REMARKS

VERSION WITH MARKINGS TO SHOW CHANGES MADE

fig.1

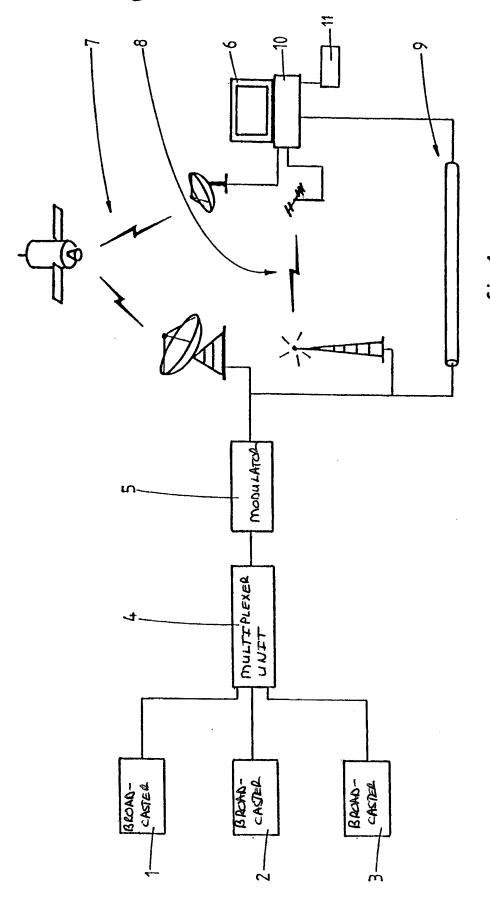
The drawings stand objected to as has not being labeled appropriately.

Appropriate corrections are indicated on the attached red-line copy of Figure 1.
